26 July 2021

Response to Section 92 RMA 'Request for Further Information' - Notice of a Requirement to Alter City Rail Link Limited Designation 2501 in the Auckland Unitary Plan (Operative in Part)

We refer to Auckland Council's request for further information dated 8 July 2021 in respect of the Notice of Requirement (NoR) to alter City Rail Link Limited (**CRL**) Designation 2501 in the Auckland Unitary Plan (Operative in Part).

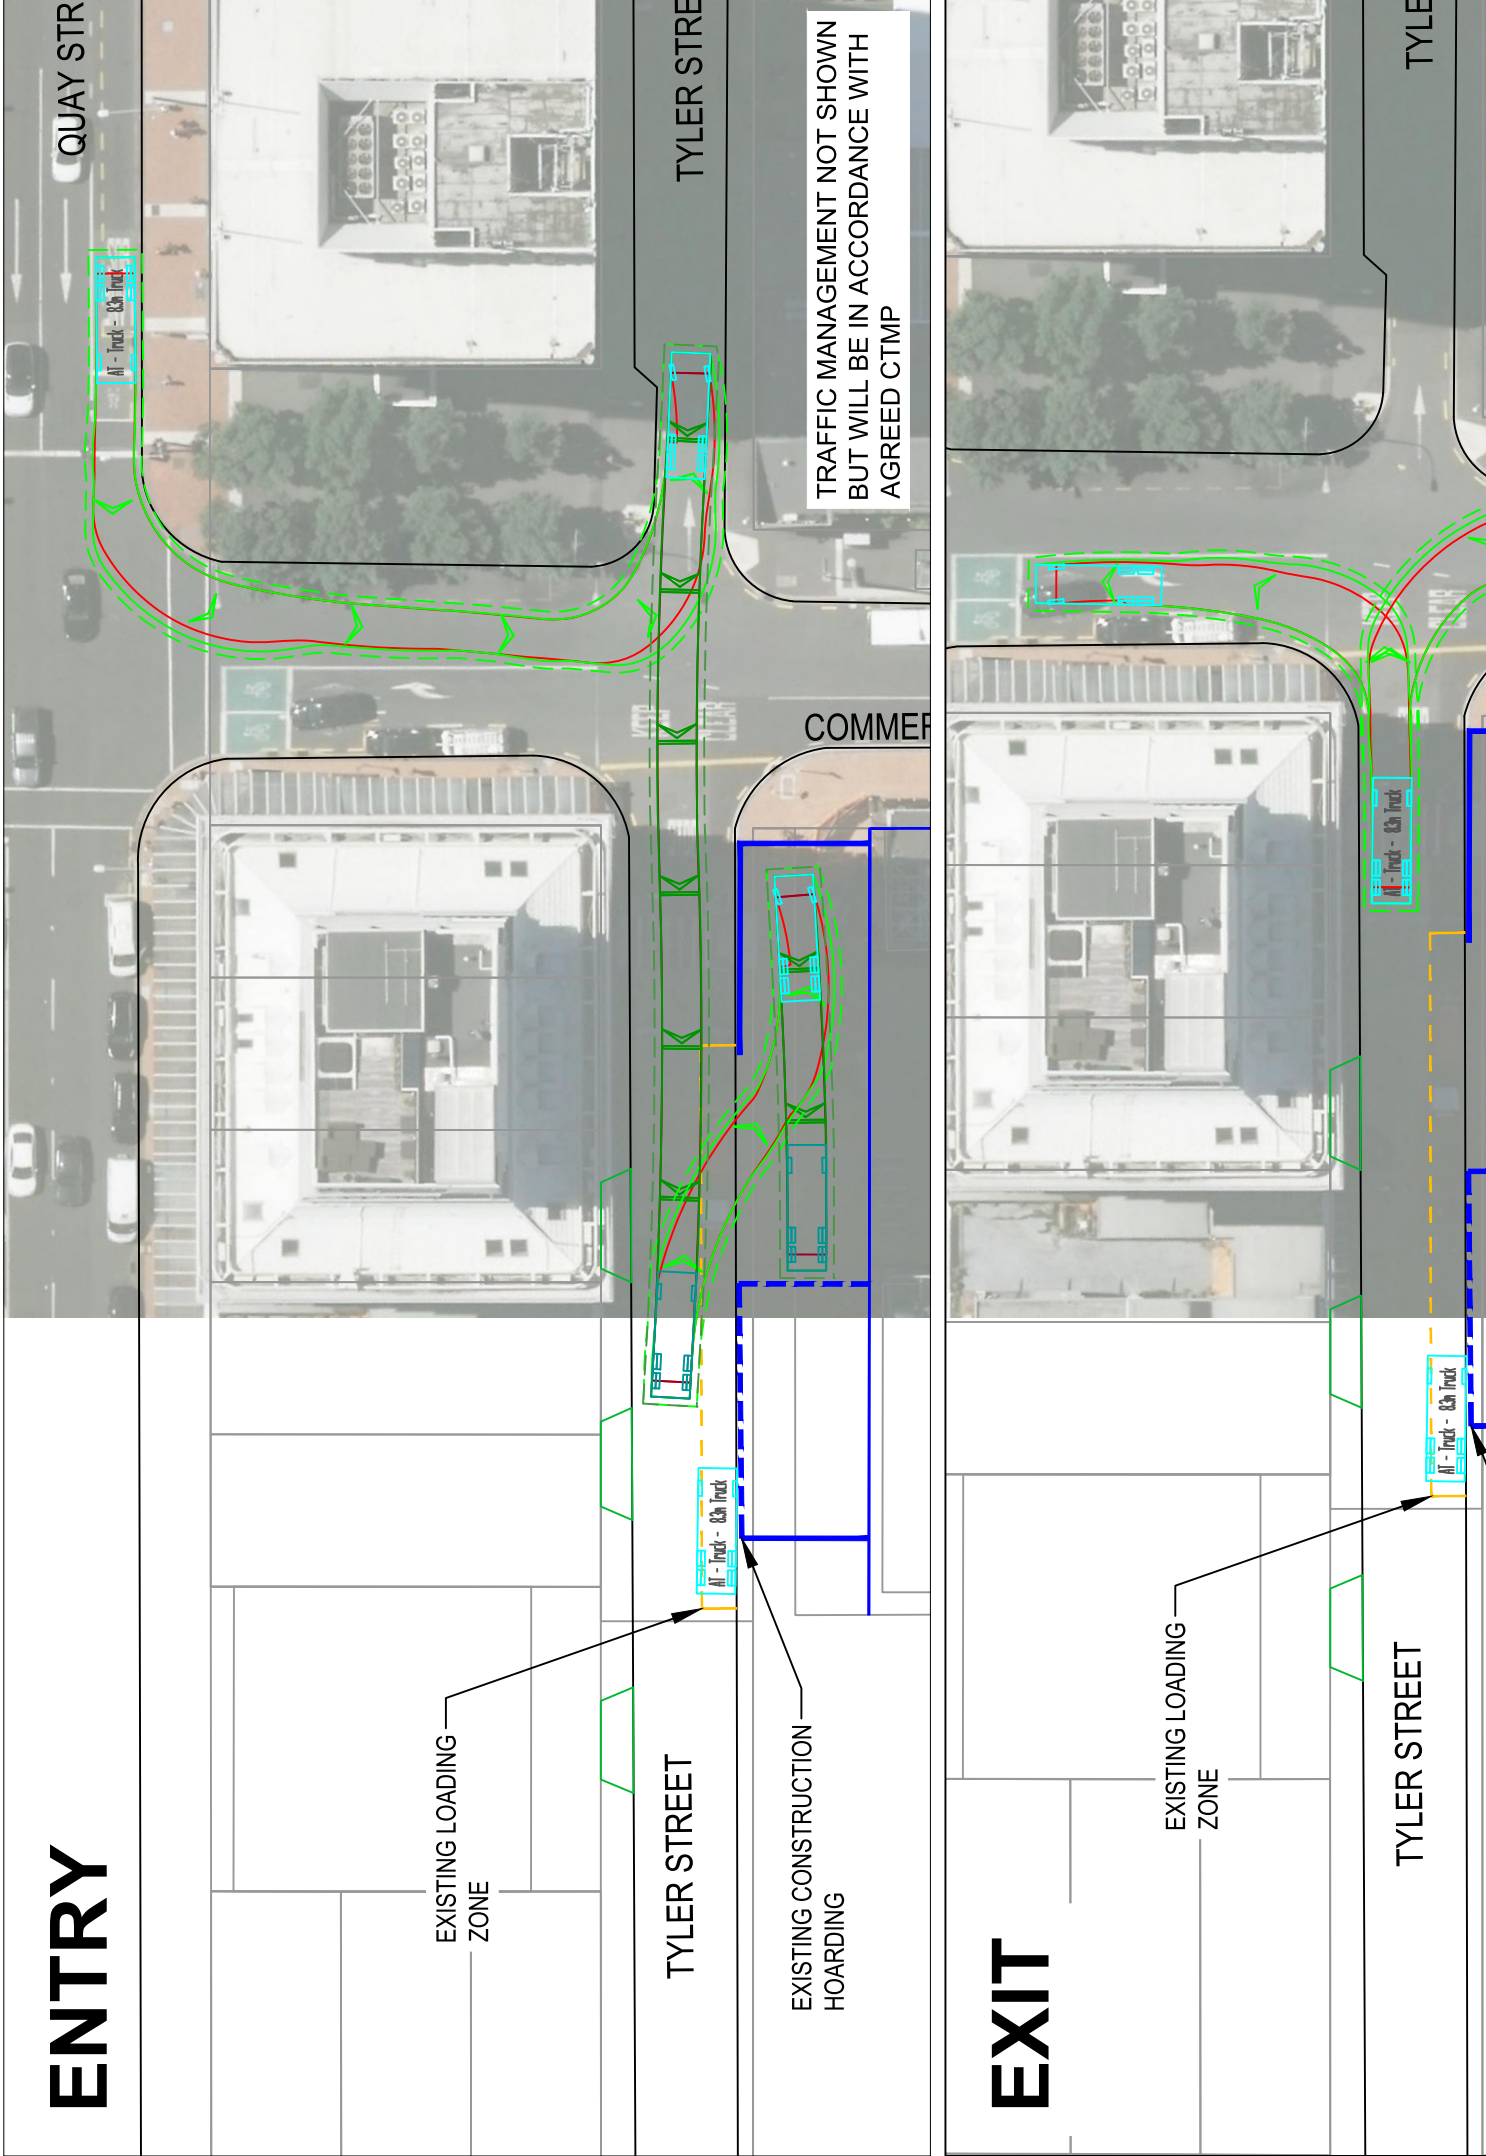
Please show vehicle tracking of the Tyler Street manoeuvres and concrete delivery access on drawings and set out a draft layout for the key traffic management measures impacting Commerce Street.

Explanation: The primary effect of the NOR identified in the ITA relates to traffic management disruptions. A Construction Traffic Management Plan (“CTMP”) approach is proposed which is a typical process and required in any situation where an activity will temporarily change the operating conditions of a road. To clearly quantify and assess the practicality of the proposed management measures and safety effects of the NOR, further information in relation to vehicle tracking is required on the drawings.

Tracking plans for a truck reversing into Tyler Street (inter peak only) or manoeuvring within Tyler Street (during the morning and evening peak periods) are attached (refer **Attachment 2**). These relate to a four-axle concrete truck of some 8.3m. (This is slightly longer than the actual vehicles that are expected to be used, these being four axle trucks of 8.1m). **Attachment 2** contains two sets of plans, with one showing how reversing is to be carried out from Commerce Street (during the inter-peak period), back onto the footpath immediately adjacent to the SPA building, and the other showing how manoeuvring can be achieved within Tyler Street within the peak periods, again using the footpath/temporary works area.

Attachment 3: C1 CRL Contract Temporary Traffic Plans

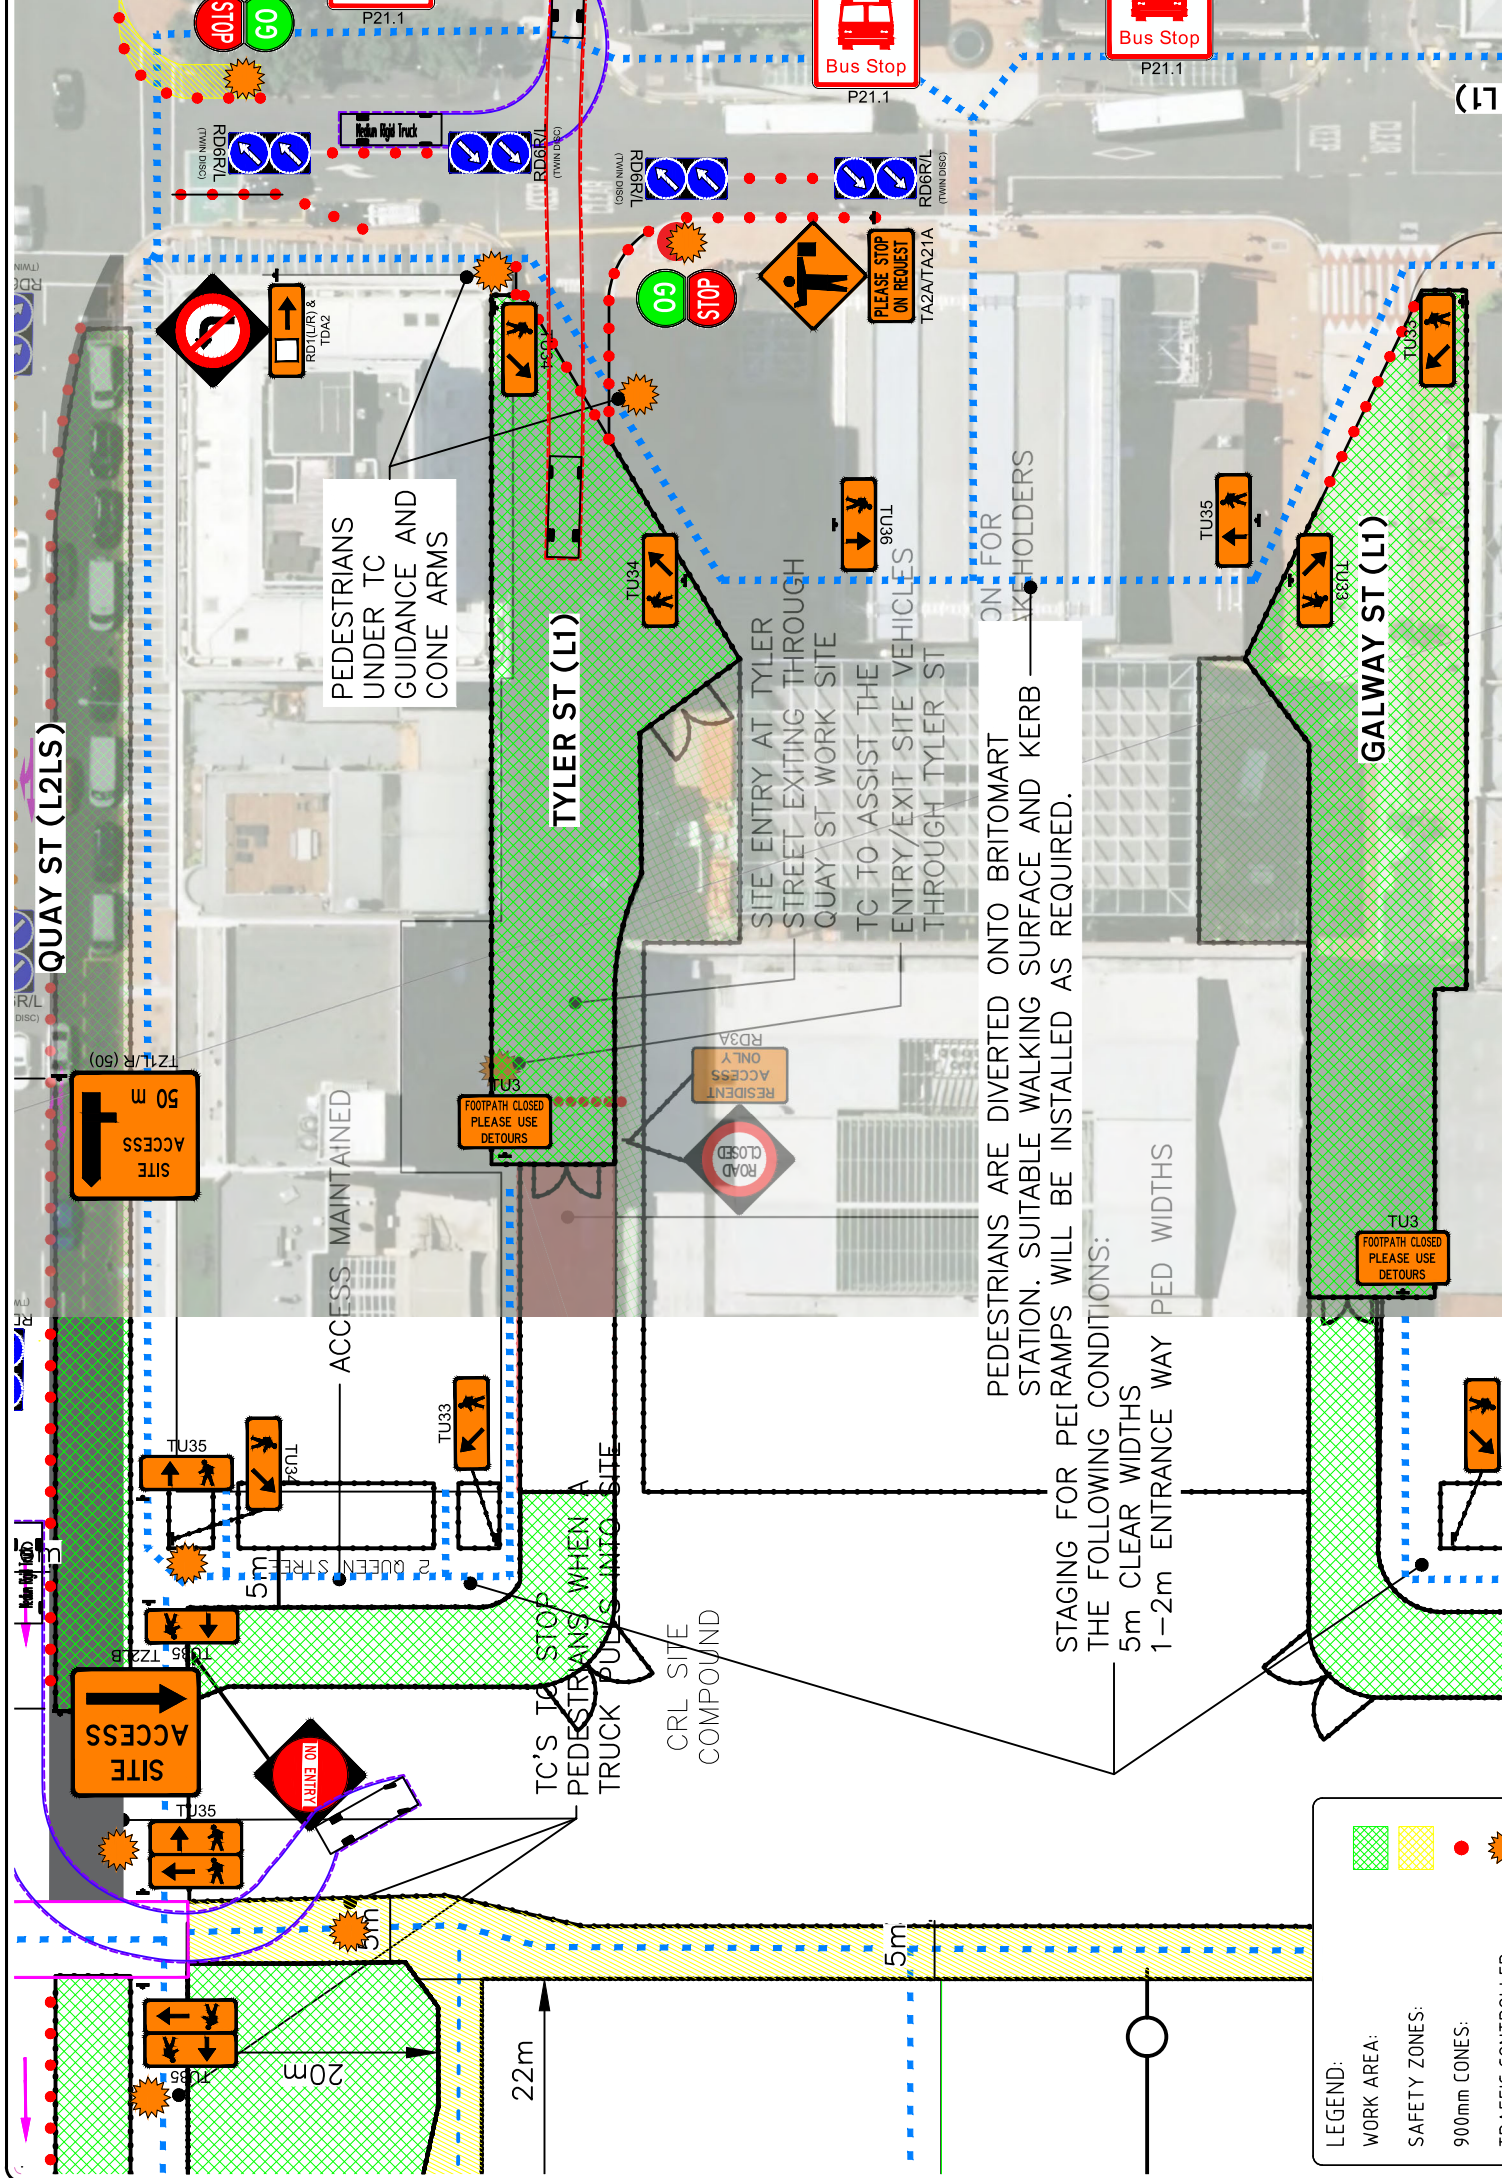
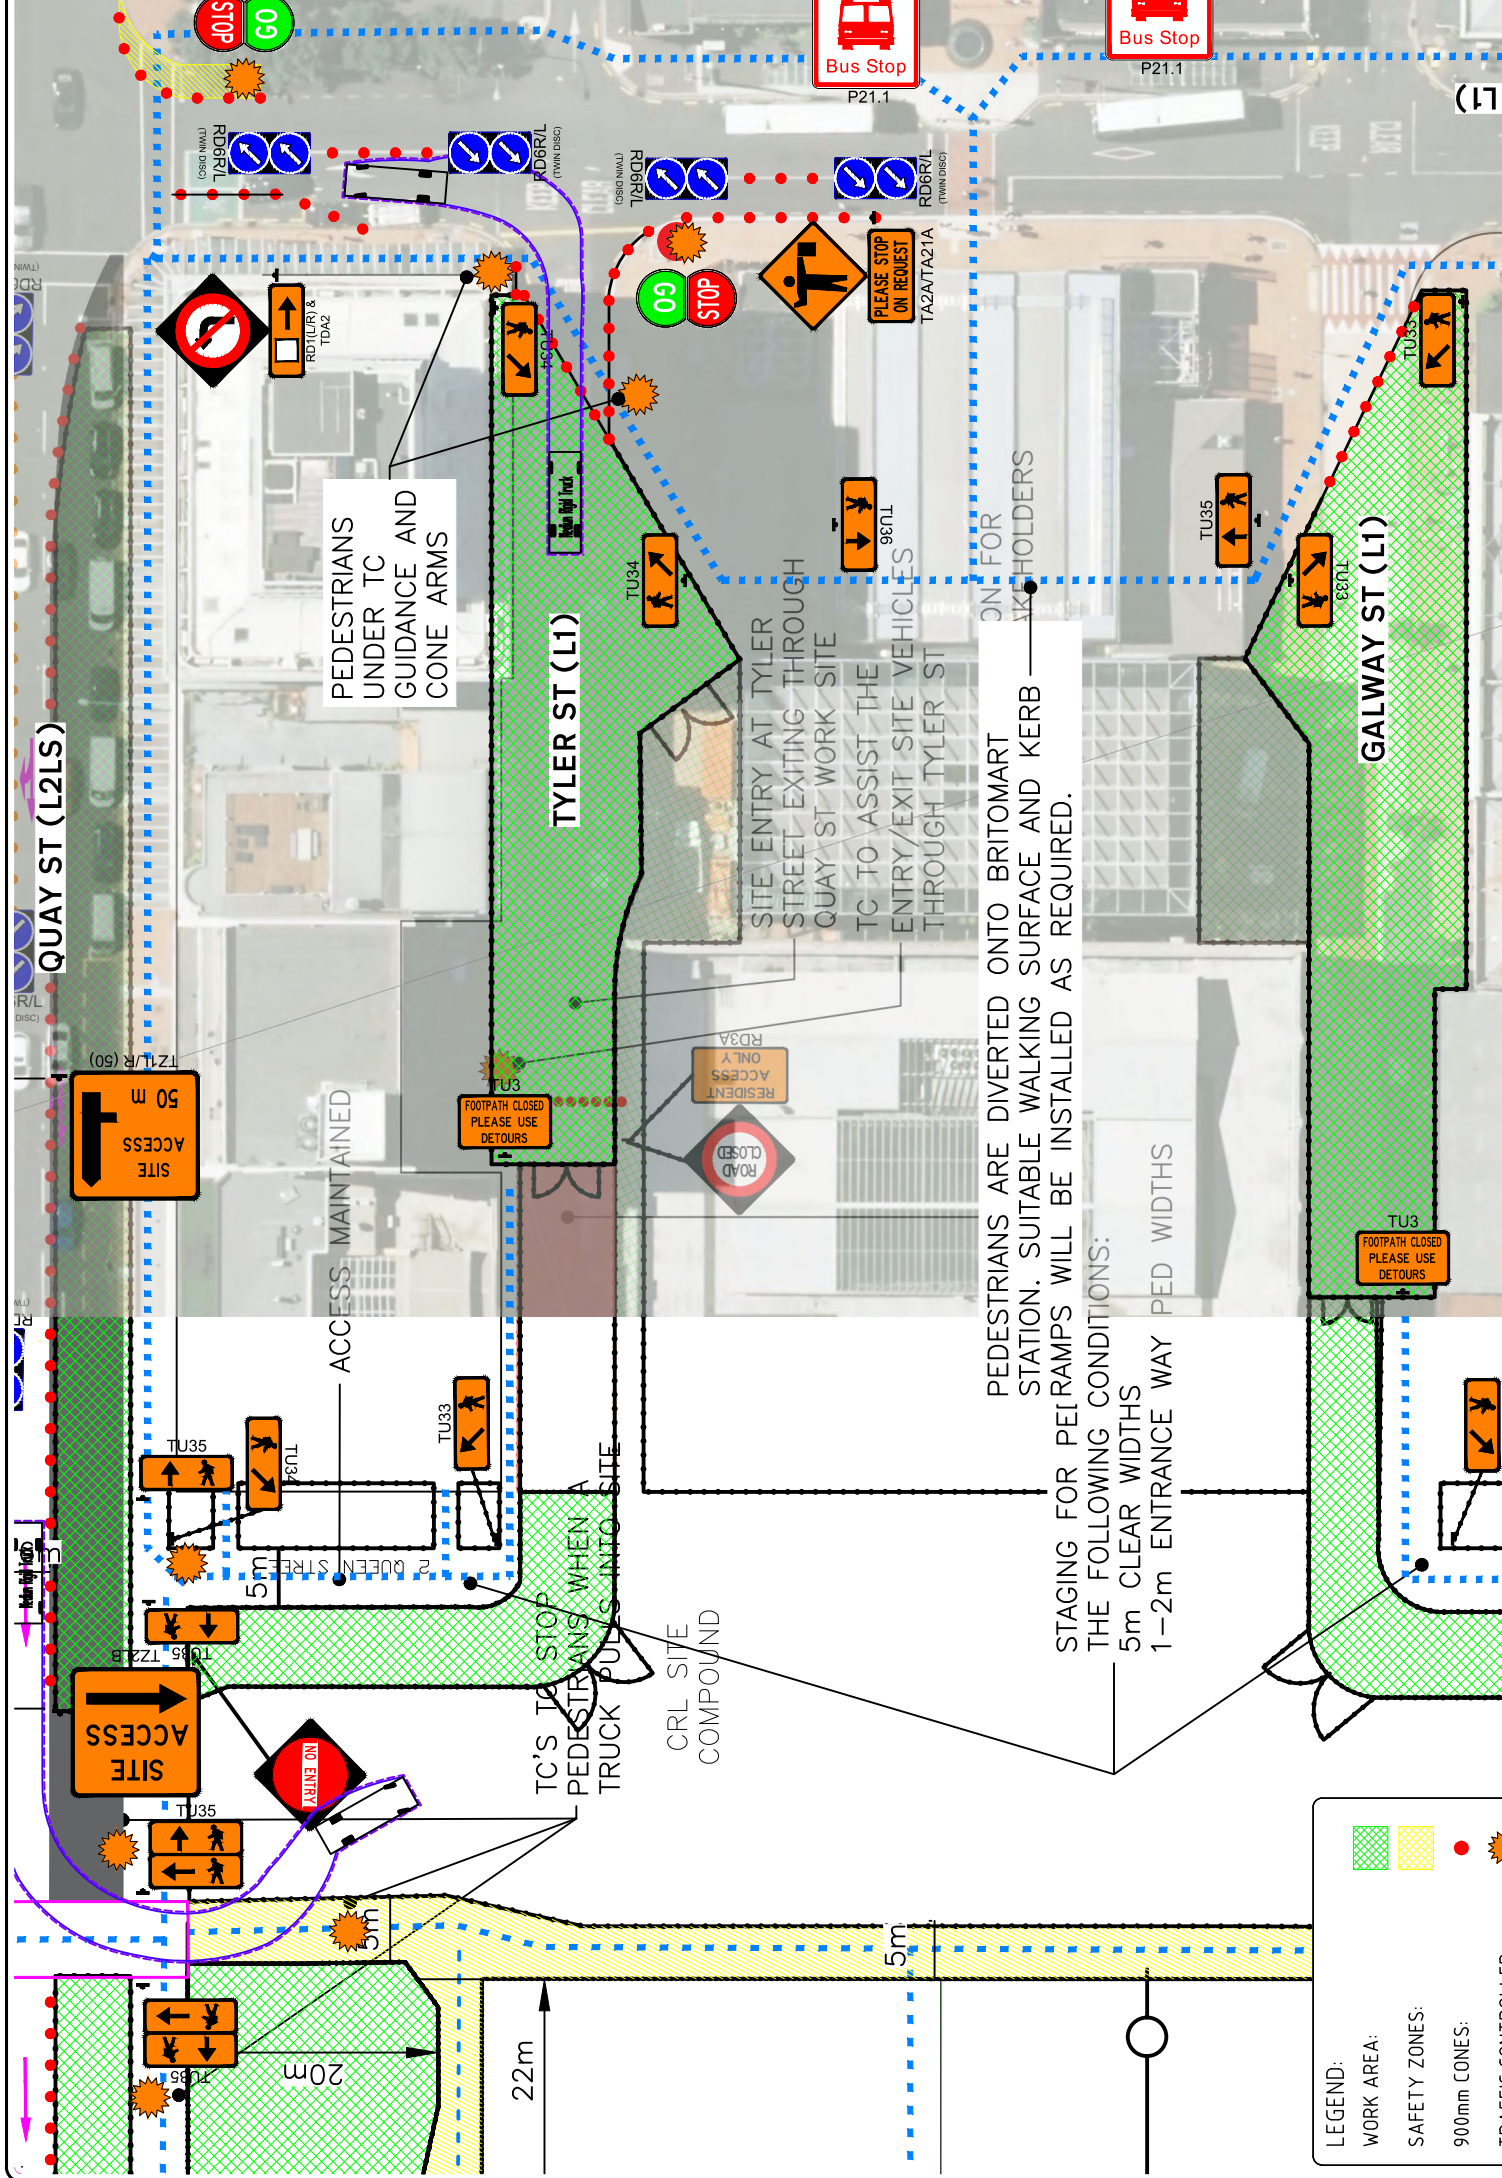
In addition, to provide confidence that safe workable solutions for site workers and the public are achievable, and existing Commerce Street activities can continue to operate as assessed, a draft layout plan outlining the key traffic management measures is required.

Detailed layout plans will be required for the temporary traffic measures to be approved by AT, in advance of the Works commencing. However, by way of example, **Attachment 3** contains plans that were approved for the earlier CRL Contract 1 works at Britomart, relating to the concept of stop/go arrangements along Commerce Street to allow reversing into Tyler Street. These are considered to be very relevant to the traffic management works now expected to be required, as they indicate the signs and locations of STMS personnel that can be expected for the Works. We anticipate similar documentation to be submitted to AT for approval of a corridor access request, prior to the Works commencing.
